## **Oulton Parish Council's submission at Deadline 6**

VATTENFALL: Norfolk Vanguard

## Hornsea Project Three

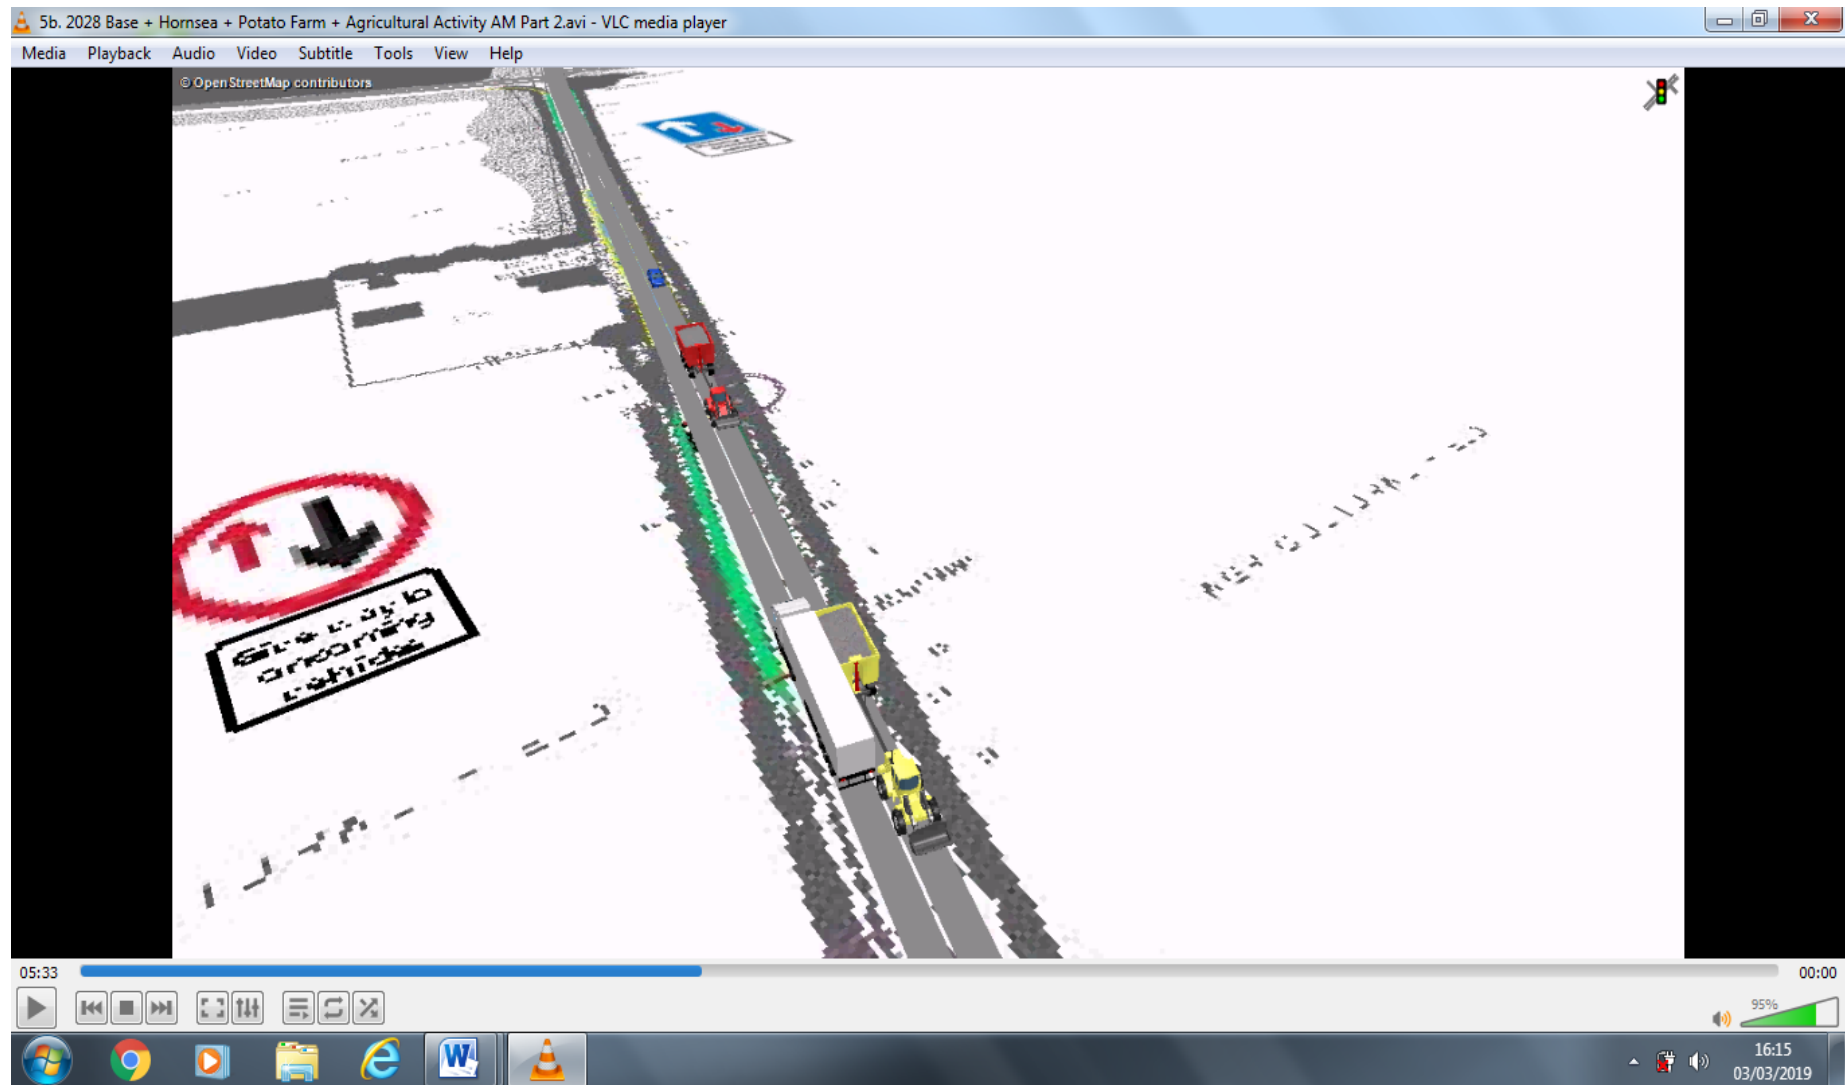
\*Priority signs at the hump next to the Railway Gatehouse not working: it would not be possible for two tractor/trailers or HGVs to pass at this point. The road width at this point is planned to be the same as currently.

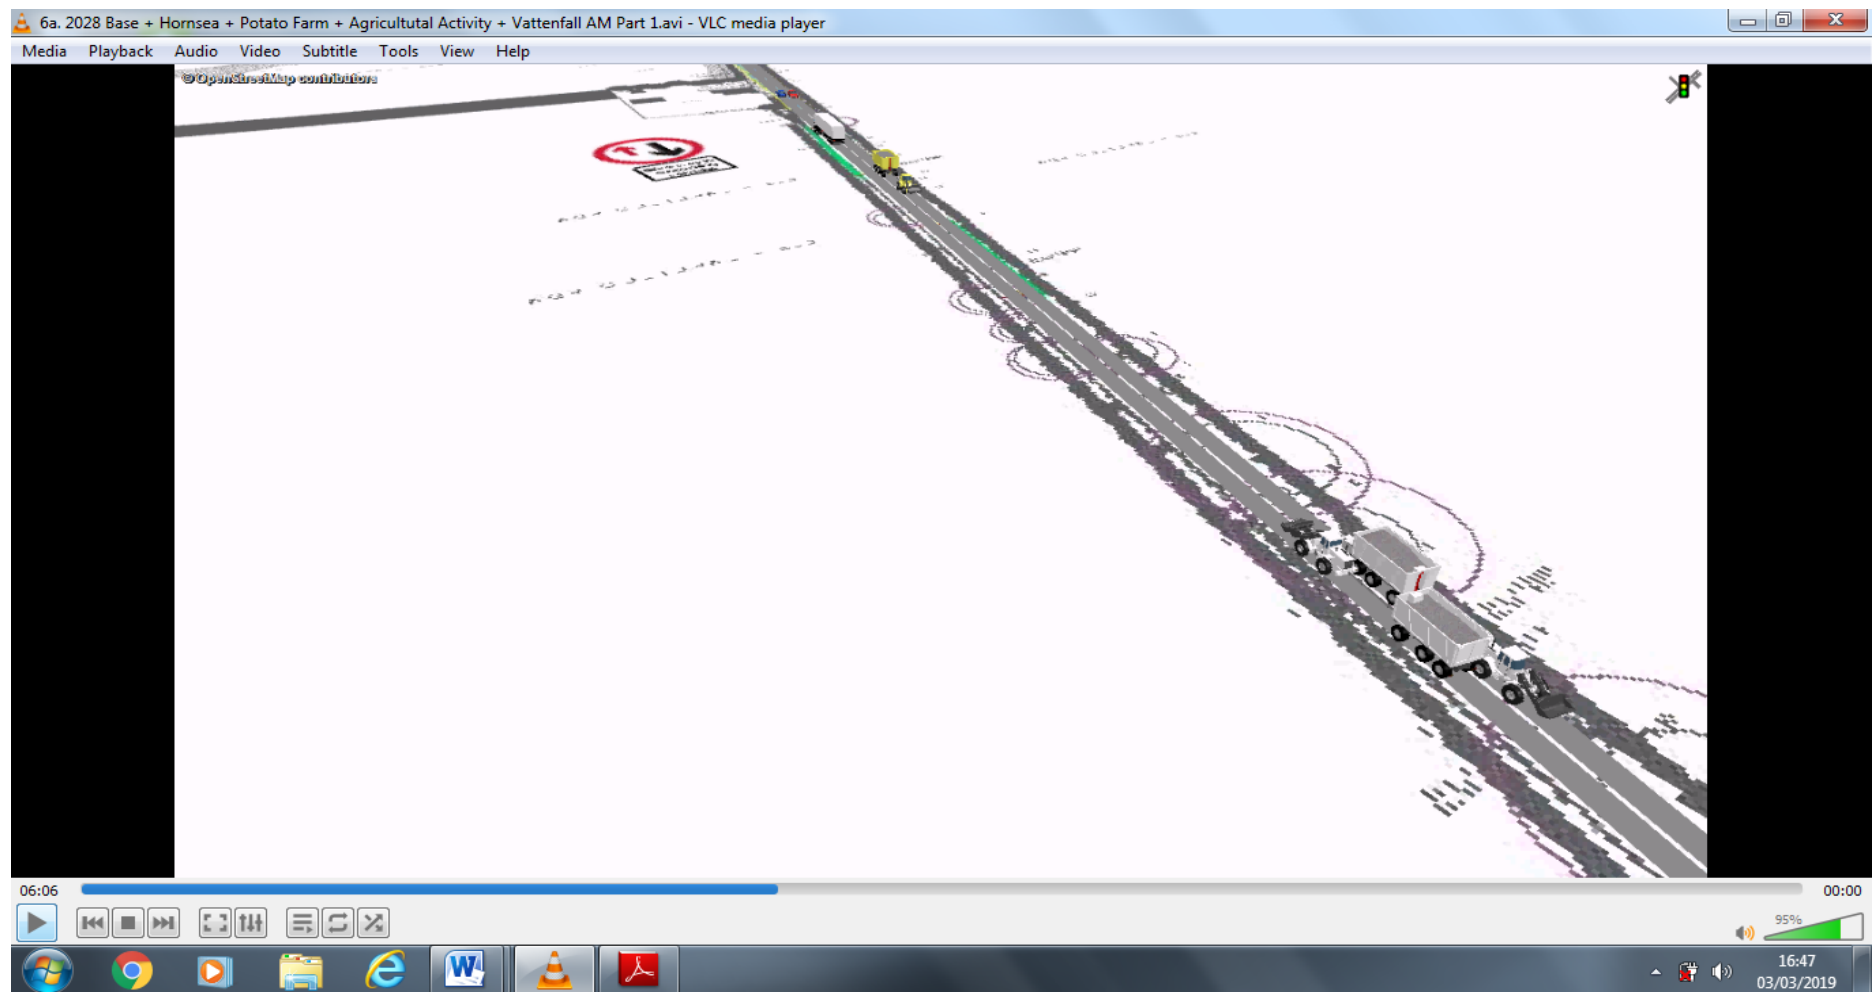
Data input error: one HGV and one tractor/trailer passing each other without use of passing place. This is impossible - the road is too narrow.

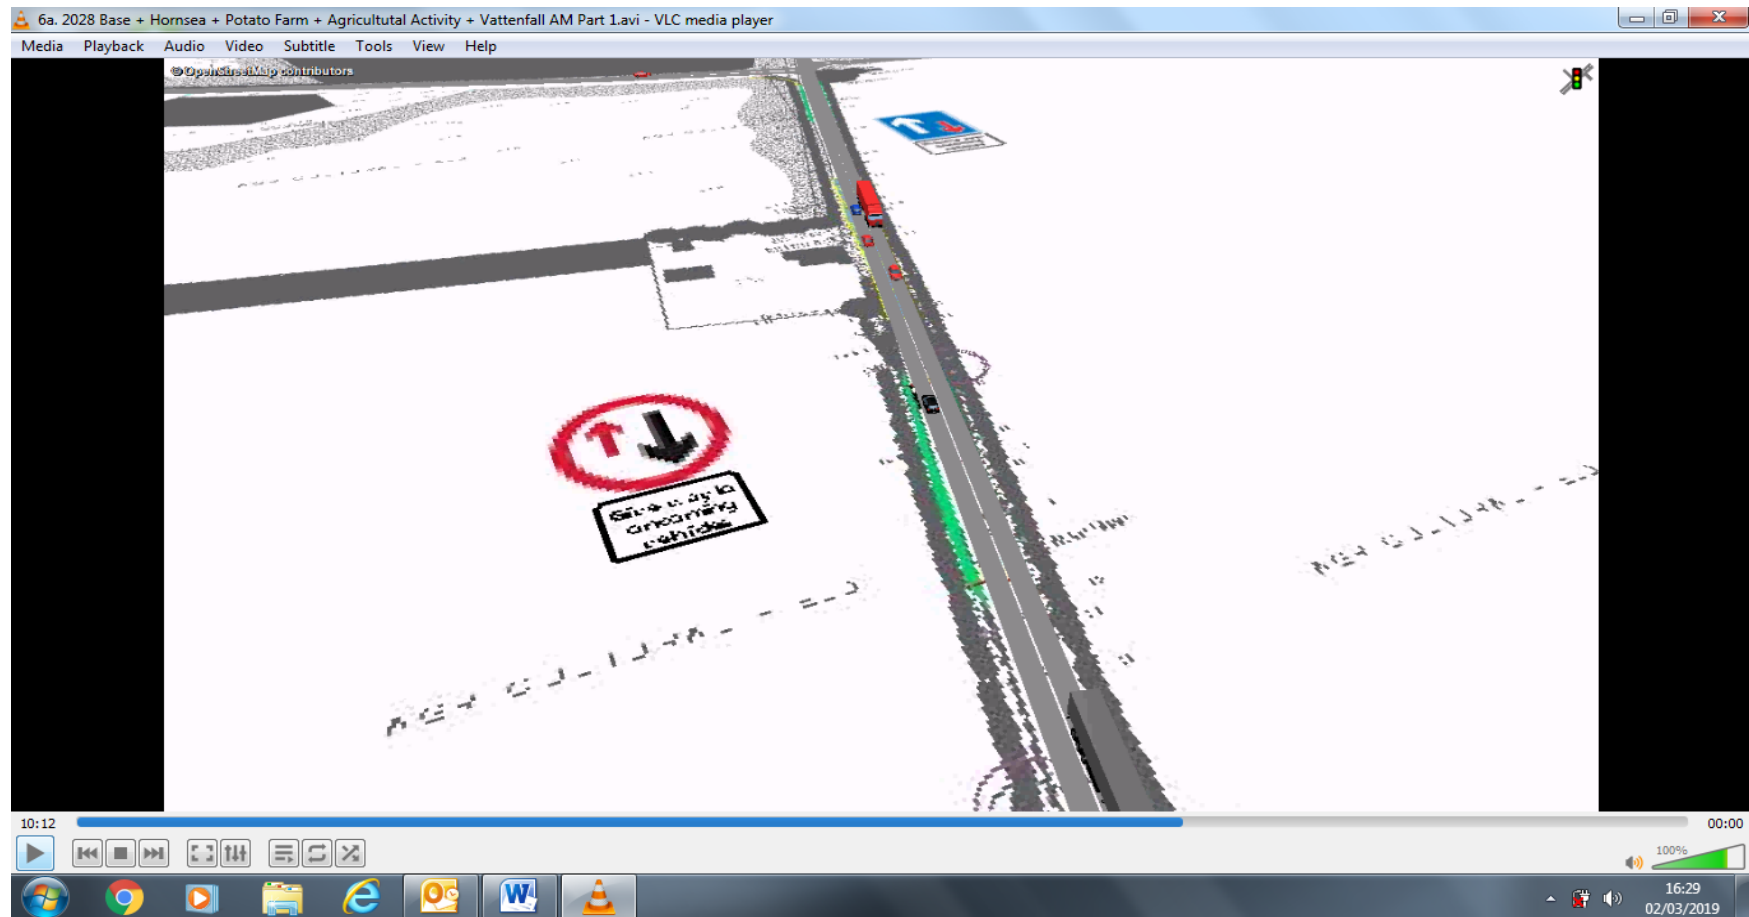
Two tractor trailers passing outside of passing places – this is impossible.  
[6a 2028 Base + Hornsea + potato Farm + agricultural activity + Vattenfall AM part 1.]

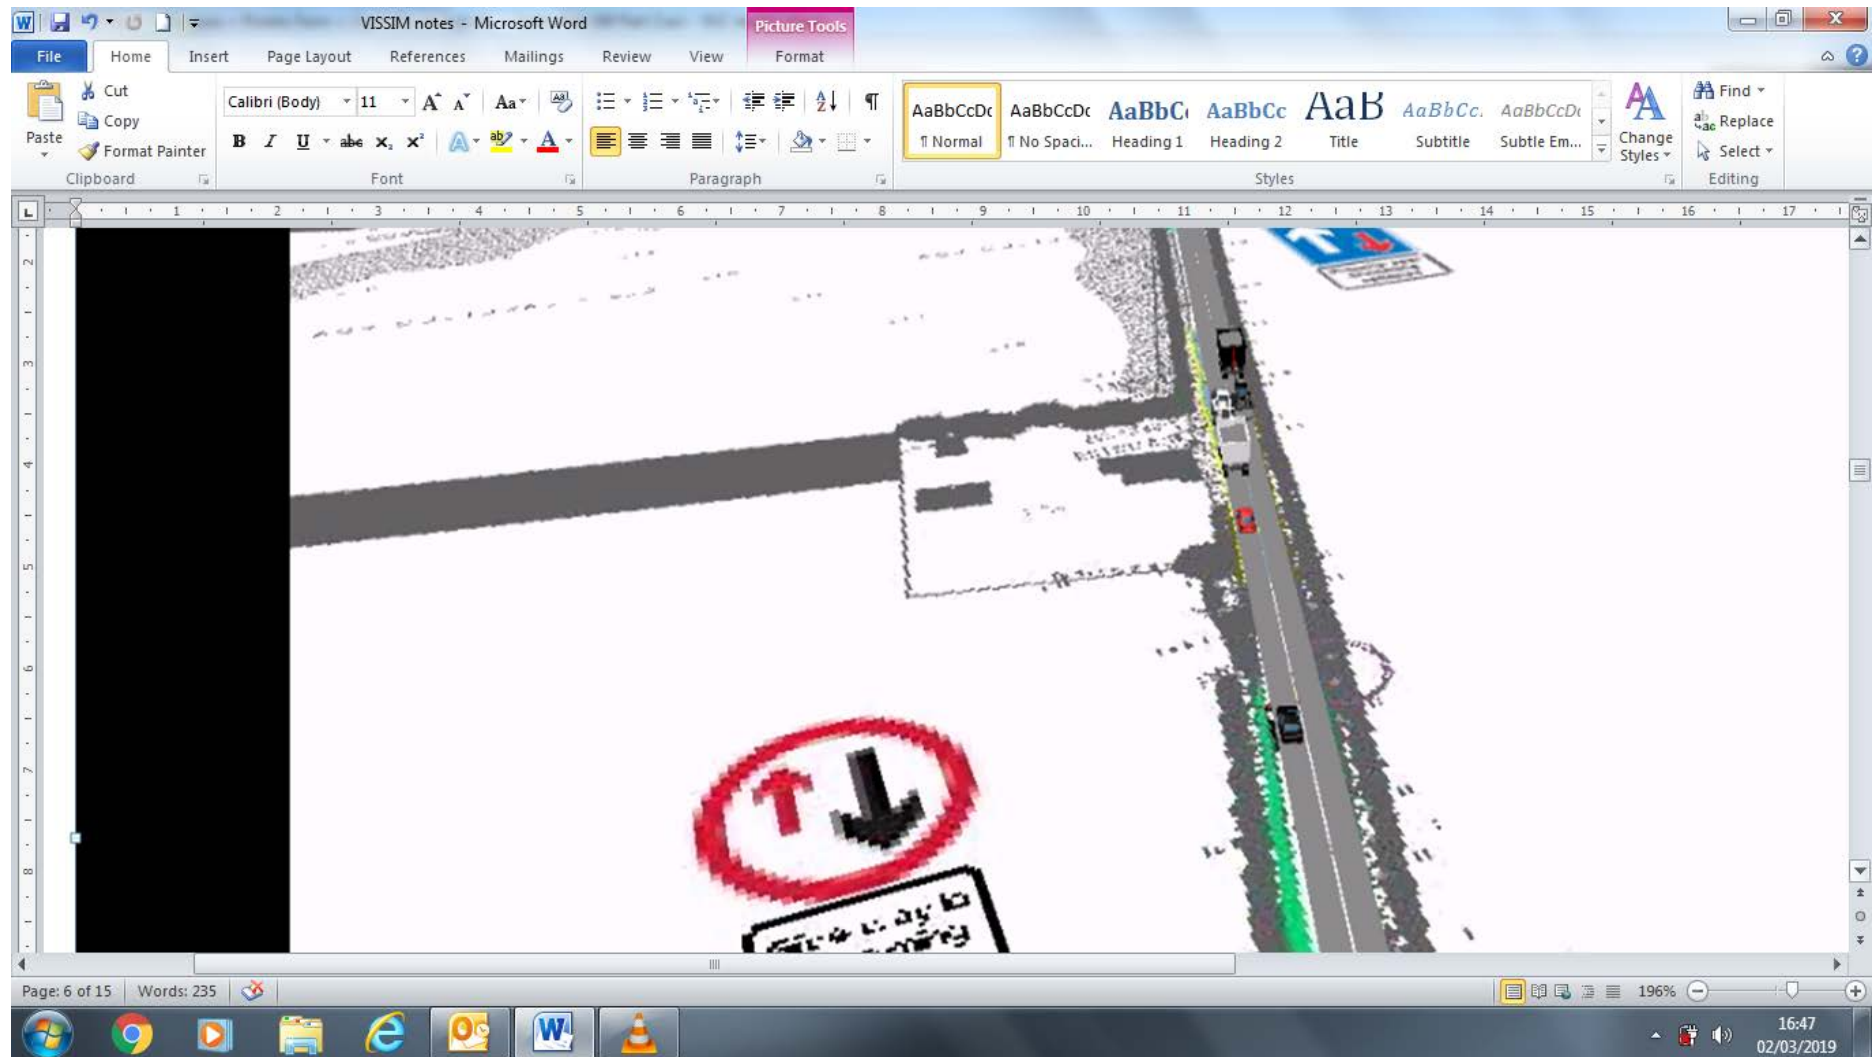
Priority signs not working at the hump: it is impossible for an HGV and a car to pass at that location.

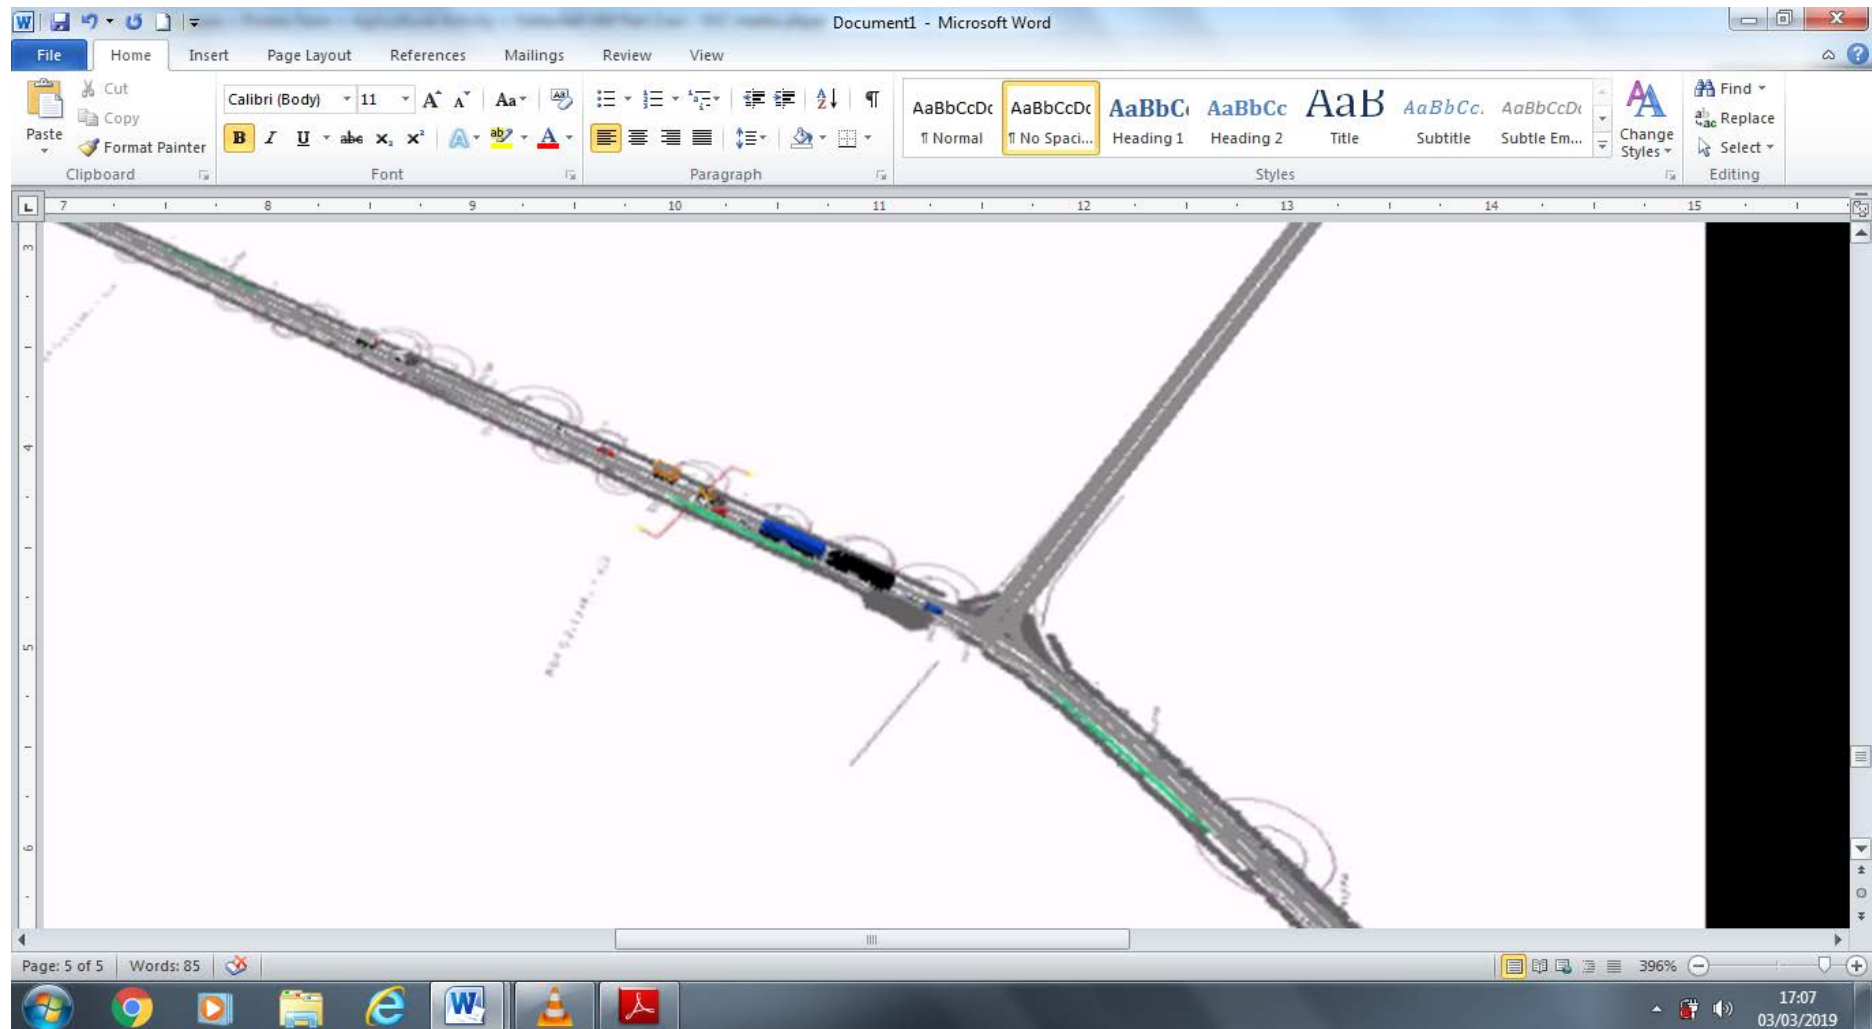
(ABOVE) Two tractors outside old railway gatehouse, potential for vehicles to overrun side of road and, in any case, the road width proposed makes such a passing impossible.

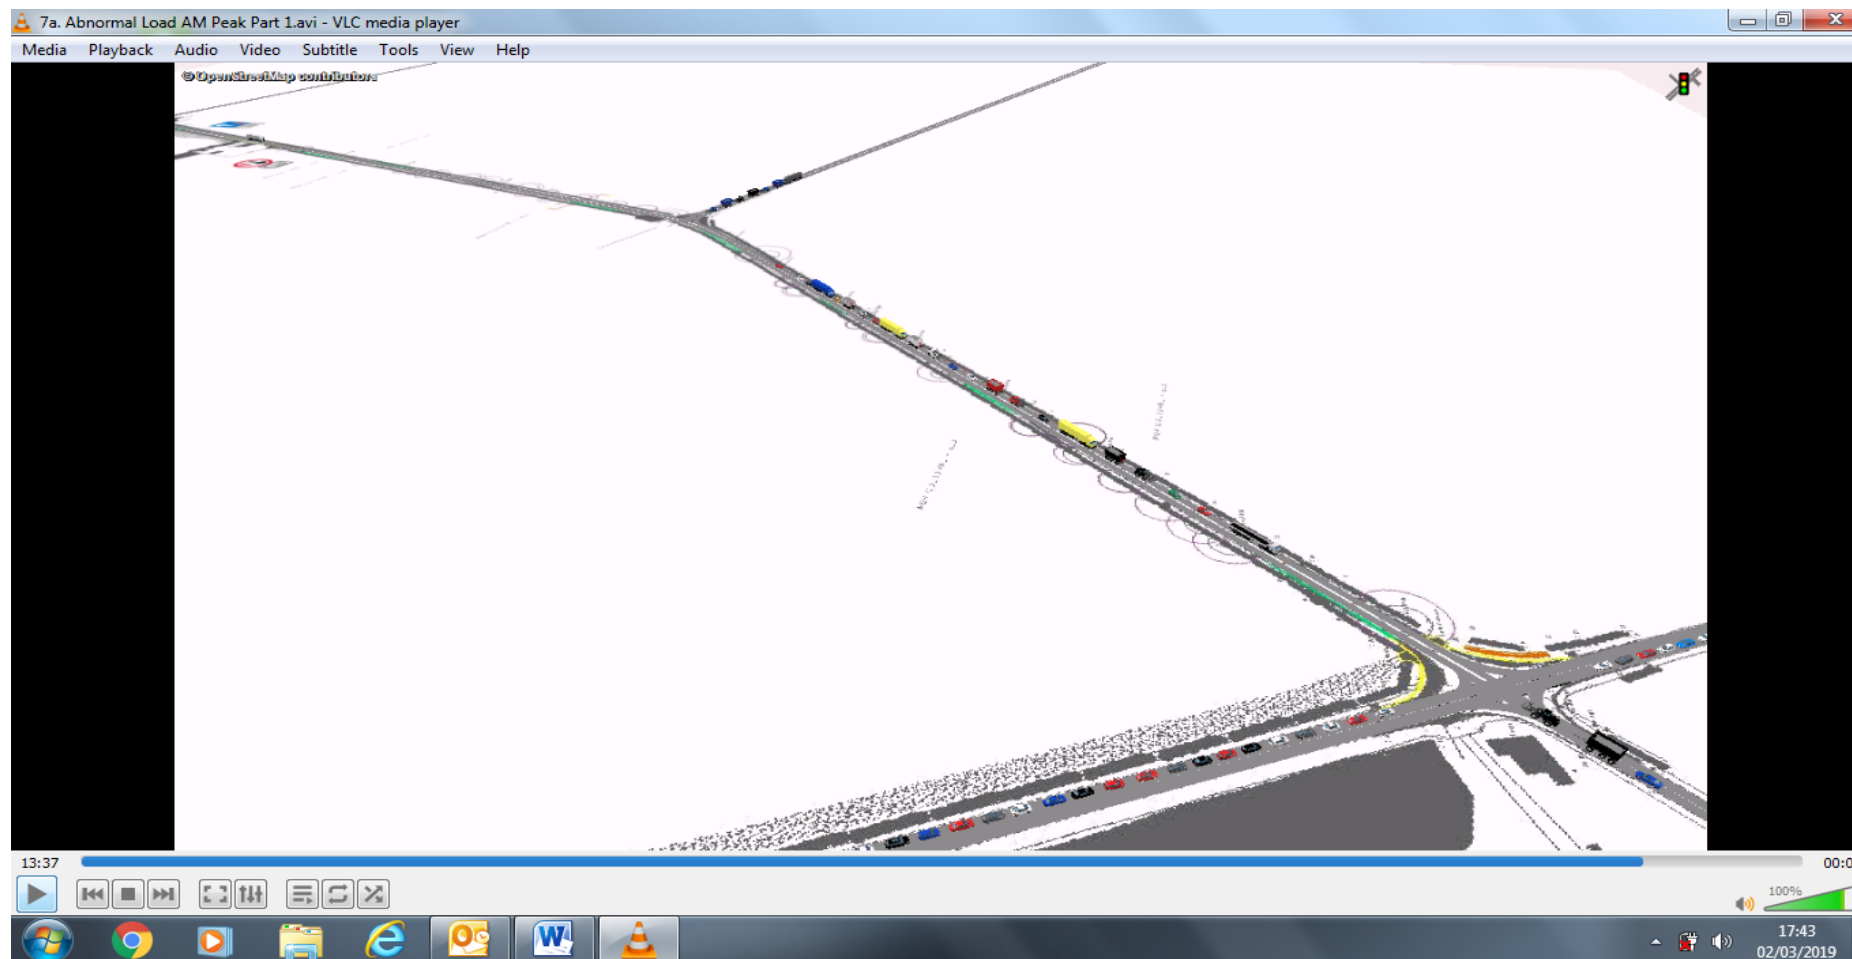
( Above) Enlarged view of bend. [6b 2028 Base + Hornsea + Potato Farm + Agricultural activity + Vattenfall AM part 2]...shows 2 cars 1 HGV in passing place  
1 HGV & 2 Cars outside of passing place at bend, waiting for oncoming traffic.(3.33sec)
